# **162.11.5 cable assembly differential to common-mode conversion loss Comment #201**

# Comment #201

CI 162 SC 162.11.5

The difference between the cable assembly differential to common-mode conversion loss and the cable assembly insertion loss shall meet Equation (162-12) illustrated in Figure 162-7.

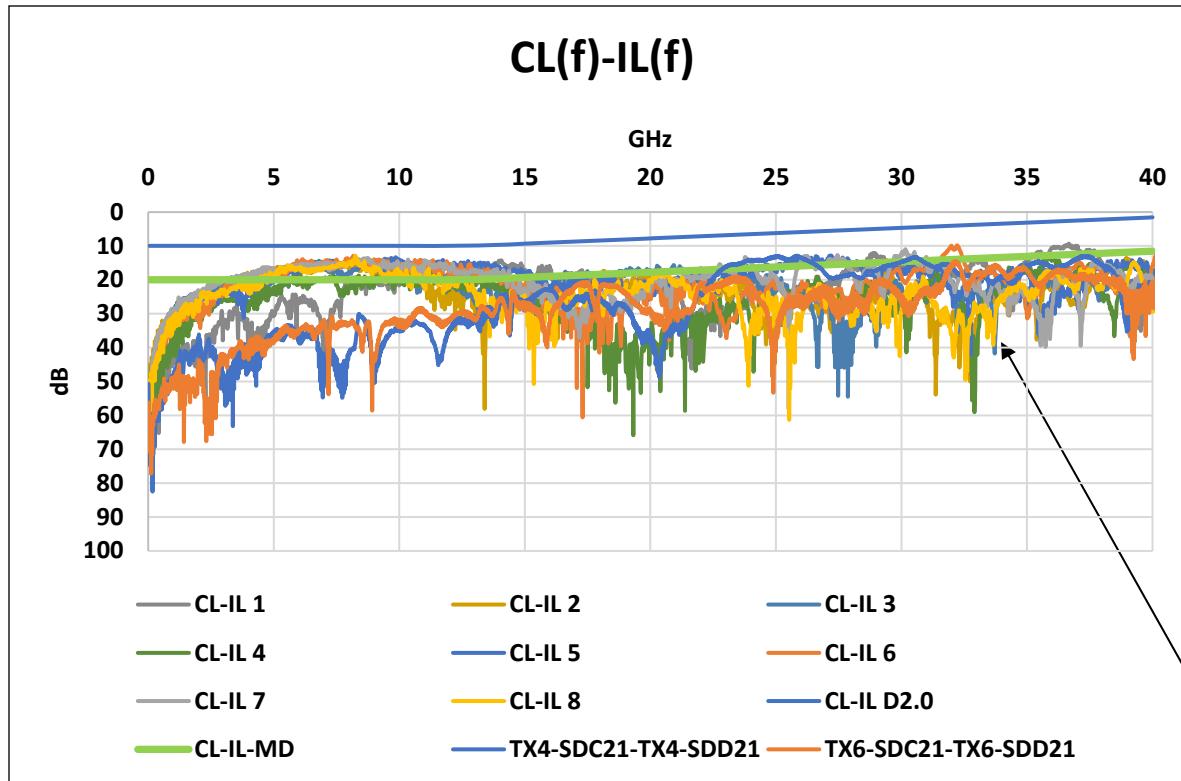
The differential to common mode conversion loss specification is very relaxed particularly at higher frequencies. As an example at 25GHz this specification is only approx 6dB more than the insertion loss. There is no specification for the common mode to common mode return loss of the Rx so all this common mode energy can be reflected back to the cable where through common mode to differential conversion it then becomes a differential signal interferer. Assuming this common mode to differential mode has approximately the same value as the differential to common mode conversion of approx 12.5dB this unwanted interferer is only 18.5dB below the wanted signal and will severely degrade the BER.

Add 10dB to this equation

PROPOSED REJECT.

The basis for a 10 dB tightening of the limit is not obvious in the stated comment and the correlation to the degradation of the BER is not provided.

# 162.11.5 Cable Assembly CL(f)-IL(f)

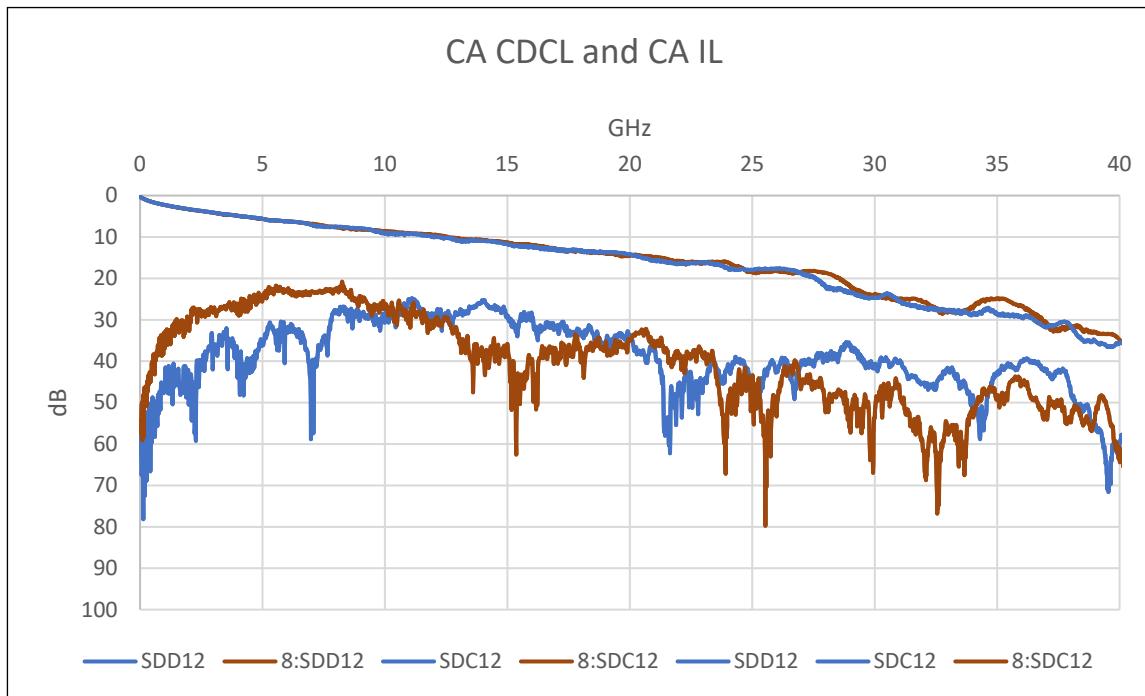
Add 10 dB to 162-12  
Proposed resultant equation [(162-12)]

$$\text{CL}(f) - \text{IL}(f) \geq 20 \text{ dB } [0.5 \leq f \text{ GHz} < 12.89] \\ 24 - 0.3108 * (f \text{ GHz}) \text{ dB } [12.89 \leq f \leq 40]$$
